2139 VALLEYGATE, #101-C

IMPROVEMENT FLOOR PLAN

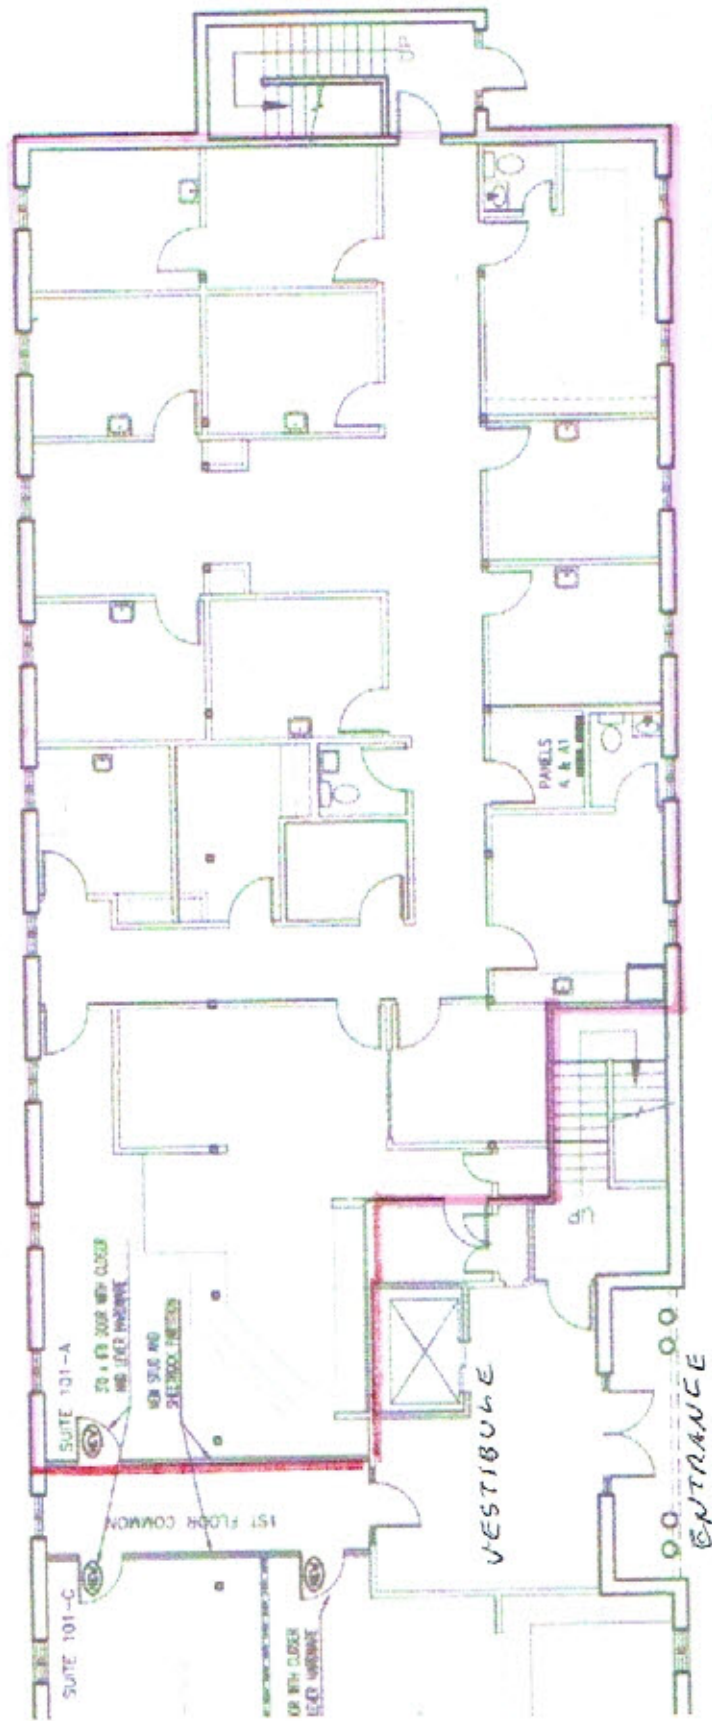
RECOMMEND DUCT IN COMMON SPACE
MINIMUM OF 1" AIR CLEARANCE

SMALL GAP BETWEEN
